**Tuesday August 28, 2018**  
**Medway Planning and Economic Development Board**  
**155 Village Street**  
**Medway, MA 02053**

**Public Review – Minor Site Plan for Medway Community Church, 9 and 11 Public Slocumb Place:**

### **Re: Medway Community Church Site Plan**

**Re: Medway Community Church  
Site Plan Review  
9 & 11 Slocumb Place  
Medway, Massachusetts**

**LIGHTING PLAN**

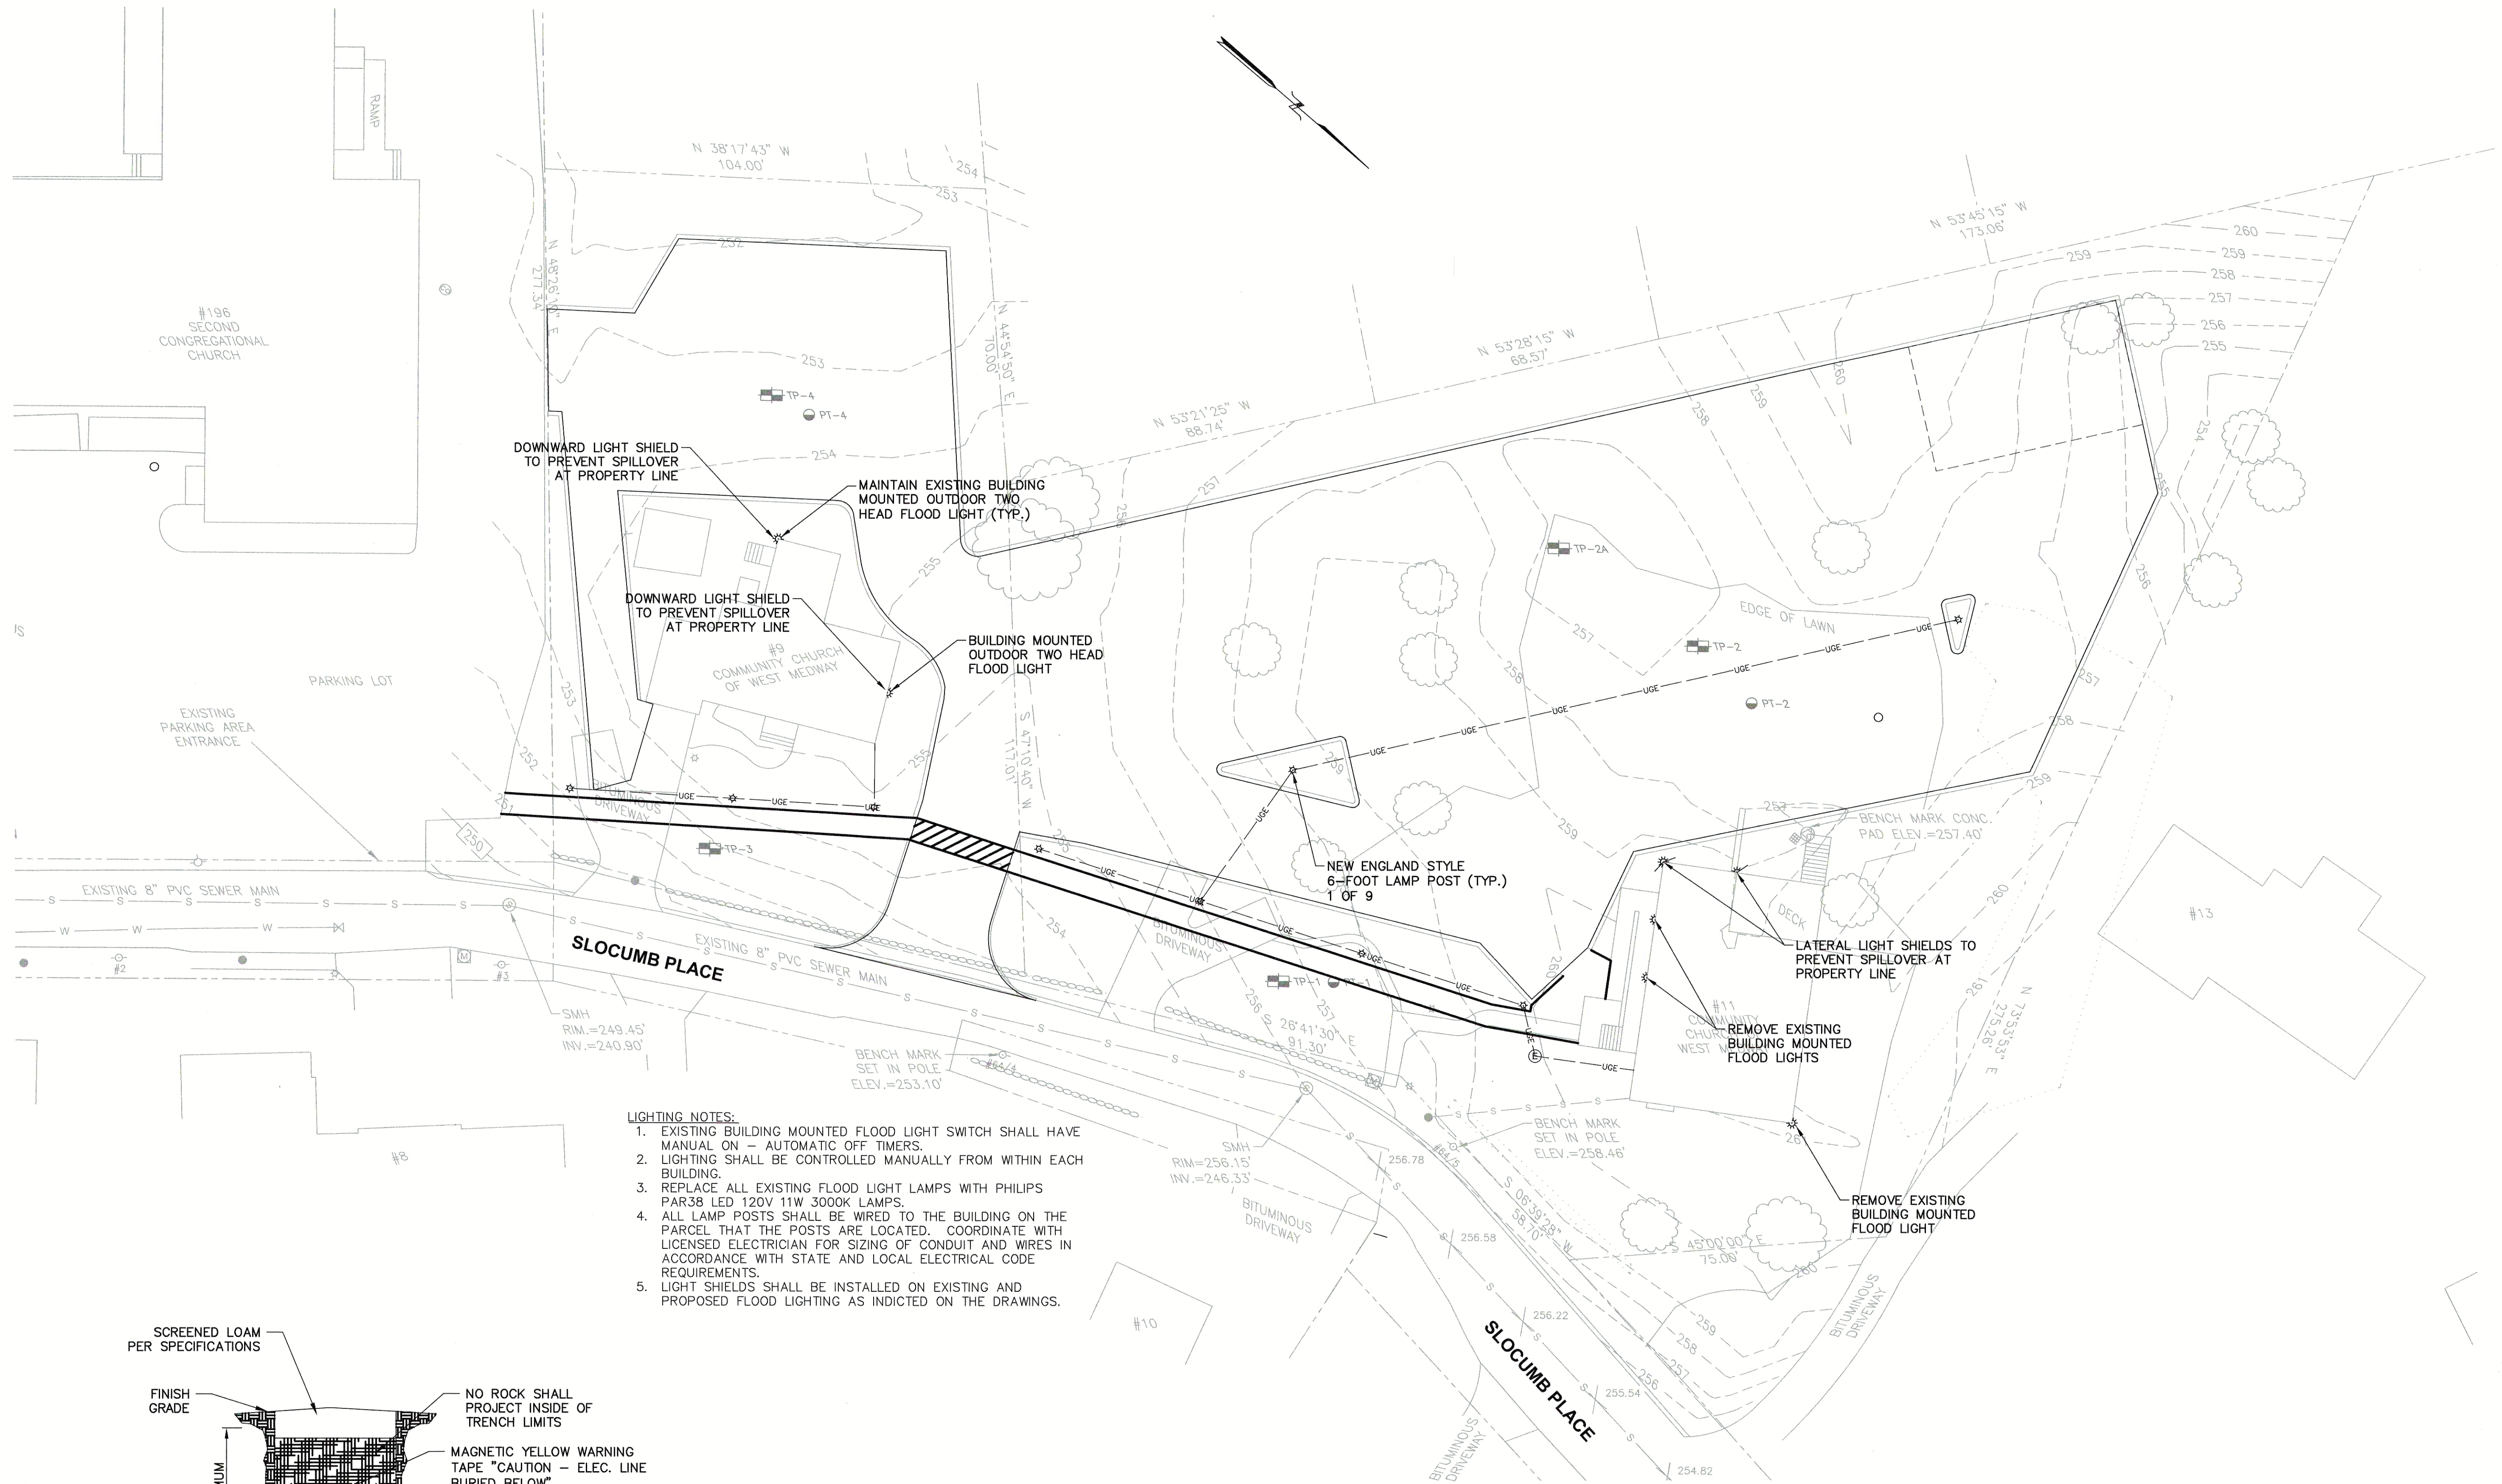
4. Section V. B. 7. (e) (1) states that light trespass onto any abutting street or lot is not permitted. The applicant states that lighting “will minimize glare and spillover to neighboring properties as well as eliminate any upright pollution from the fixtures through the use of shields, baffles, or tinted lenses.” However, no photometric plan was submitted to document this. **A photometric plan documenting compliance has now been added to the plan set. OK. The lighting plan also indicates that all lights will be manually controlled within the buildings but also have timers for automatic shutoffs. OK.**

- TT 8/24/18 Update: In our opinion, this item has been addressed.
- 6) A Site Utilities Plan is not provided in the Plans. Means for powering proposed parking lot lamp posts is not provided. (§204-5.D.6)

- LIGHTING NOTES:**
1. EXISTING BUILDING MOUNTED FLOOD LIGHT SWITCH SHALL HAVE MANUAL ON - AUTOMATIC OFF TIMERS.
  2. LIGHTING SHALL BE CONTROLLED MANUALLY FROM WITHIN EACH BUILDING.
  3. REPLACE ALL EXISTING FLOOD LIGHT LAMPS WITH PHILIPS PAR38 LED 120V 11W 3000K LAMPS.
  4. ALL LAMP POSTS SHALL BE WIRED TO THE BUILDING ON THE PARCEL THAT THE POSTS ARE LOCATED. COORDINATE WITH LICENSED ELECTRICIAN FOR SIZING OF CONDUIT AND WIRES IN ACCORDANCE WITH STATE AND LOCAL ELECTRICAL CODE REQUIREMENTS.
  5. LIGHT SHIELDS SHALL BE INSTALLED ON EXISTING AND PROPOSED FLOOD LIGHTING AS INDICATED ON THE DRAWINGS.

- *THI 8/14/18 Response: The plans shall be revised to include the approximate location of the conduits for the proposed parking lot lamp posts. Conduit and wire sizing will be as required by local codes and installed by a licensed and insured electrician prior to final grading and paving.*

**PHOTOMETRIC PLAN**  
SCALE: 1" = 20'

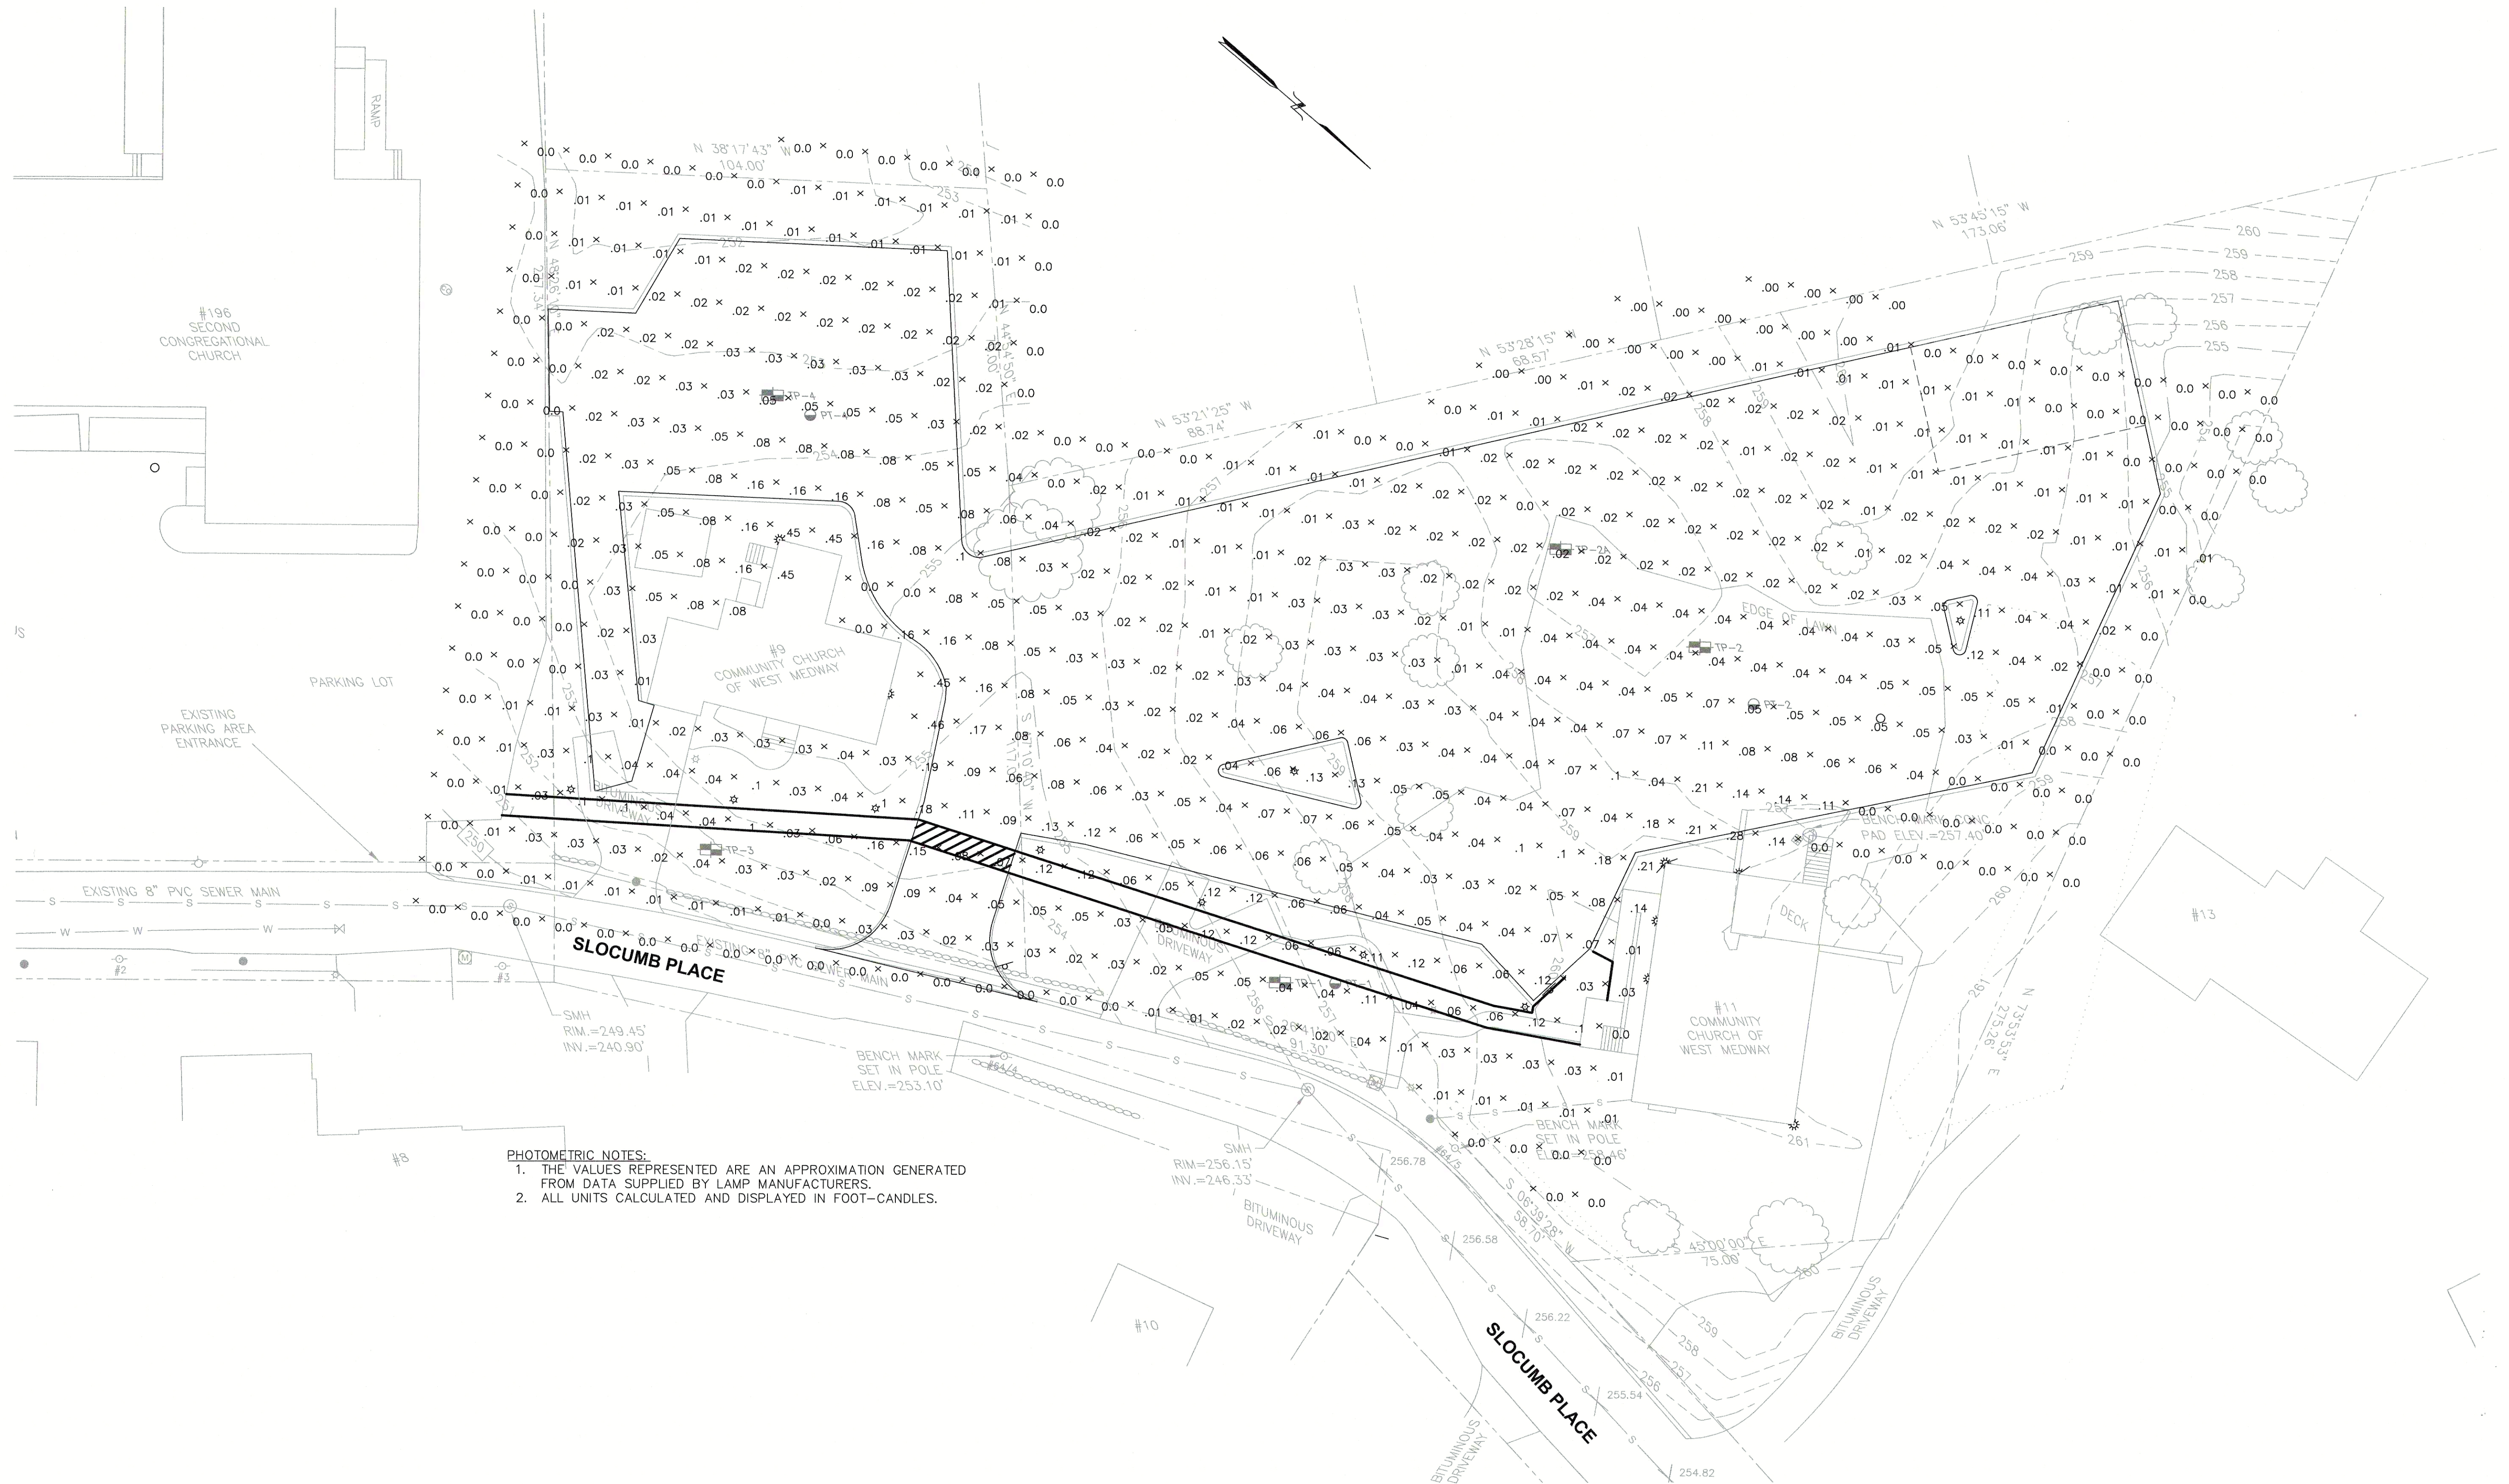
12. Section 204-5 D. (13) requires a lighting plan. As noted above, no photometric plan was provided. Also, no detail is provided to illustrate the appearance of the lighting poles and fixtures. A note says they will be “New England style post-mounted walkway fixtures and building-mounted flood lights.” **A lighting plan is now included. Illustrations of the proposed fixtures have not been included.**

- TT 8/24/18 Update: In our opinion, this item has been addressed.
- 9) Given the proximity to abutting residential properties, a photometric plan including all exterior lights should be provided confirming no light trespass on abutting properties. Times of illumination should also be provided. (§204-5.D.13)

- *THI 8/14/18 Response: Acknowledged. The plans and application shall be revised to include a photometric plan, times of illumination, and appearance of light fixtures.*
